PREPARED FOR THE PLAN COMMISSION

Project Address: 405-407 & 431 W Gorham Street, 408-430 W Johnson Street, and 304-318 N Broom Street (District 3 – Alder Verveer)

Application Type: Demolition Permit, Land Use Restriction Agreement, Zoning Text Amendment, Zoning Map Amendment, Conditional Use, and Certified Survey Map Referral

Prepared By: Chris Wells, Planning Division
Report includes comments from other City agencies, as noted.

Image 2: The development's four building 'expressions' (masses)

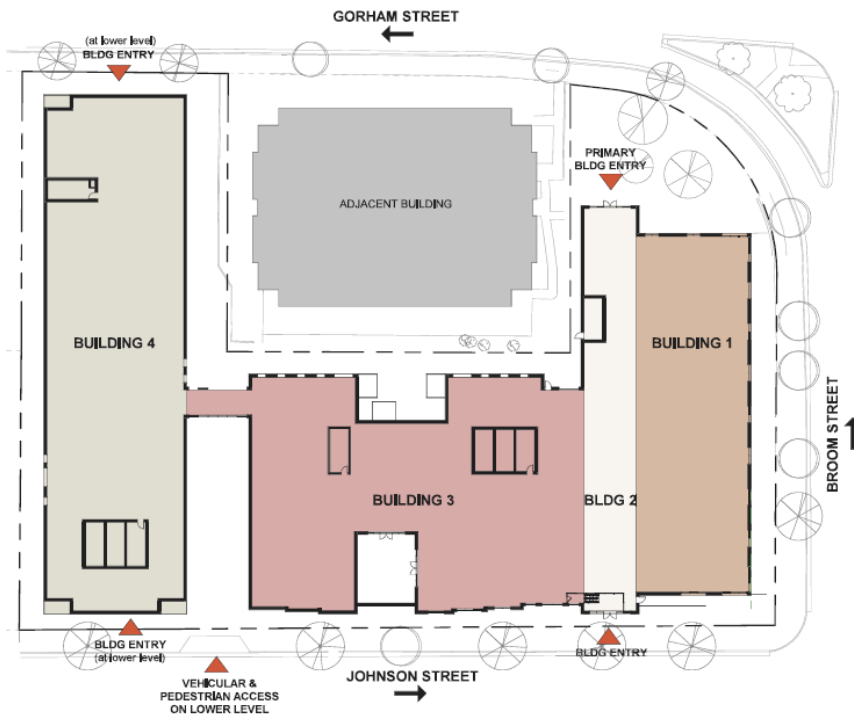
Staff have a few concerns related to the building’s design. The first, which was raised at the Urban Design Commission meeting on November 1, is the lack of ground-floor entrances along the entire 185-foot N Broom Street façade as well as roughly 230 feet of the W Johnson Street frontage. Staff note that the UDC at their aforementioned meeting on November 1, added a condition that an additional connection to the street be incorporated along the W Johnson Street frontage. Staff however still believe that an additional entrance is needed along the N Broom Street frontage noting that, if the Building 1 were a stand-alone building, that a primary entrance oriented to the primary abutting street would be required. (Staff acknowledge that an entrance facing W Gorham could meet this requirement if it were located at or wrapped the north corner).

The second concern is the significant blank wall expanse located on the upper floors of the southwest façade of Building 2 (see Sheet 36 “Elevation Promenade Bldg 3” in the submitted materials). The units on the first eight floors of that façade have multiple windows while the units on Floors 9-14 have none, despite the fact that the upper floors would actually afford a view and be less obscured by the adjacent 12-story Equinox building. When brought up to the applicant, they responded with the following, *“As presented to and approved by UDC, this area on the back side of building 2 is predominately bathrooms on the floors 9-14. This is in the narrow section of the building 2 and the design pushes the living room/kitchen/bedrooms to the Broom- and Gorham-facing facades to maximize views. This section of the building is also effectively screened from view by the Equinox as the building is pulled back from the street frontage and the two buildings are closest together along this property line.”* To this end, Staff note that the northwest façade of Building 2 is set approximately 50 feet further back from W Gorham Street than the same façade of the adjacent 12-story Equinox building meaning the views of the section of blank façade from the public right-of-way will be extremely limited.

2. Before any permits, including demolition permits, are issued for this project, the plans shall receive final approval from the Urban Design Commission, addressing the following consideration:
 - a) That a connection to the street be incorporated along the W Johnson Street frontage.
